— Main Positive Feedback —

— Main Critique Points —

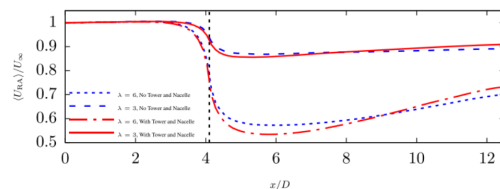
- To strengthen this part, I would suggest either limiting the cross-paper comparison, or alternatively presenting a direct comparison in the present manuscript — for instance, by reproducing a nondimensionalized plot from Santoni et al. (2017):

in a comparable format that allows readers to interpret the differences more clearly.
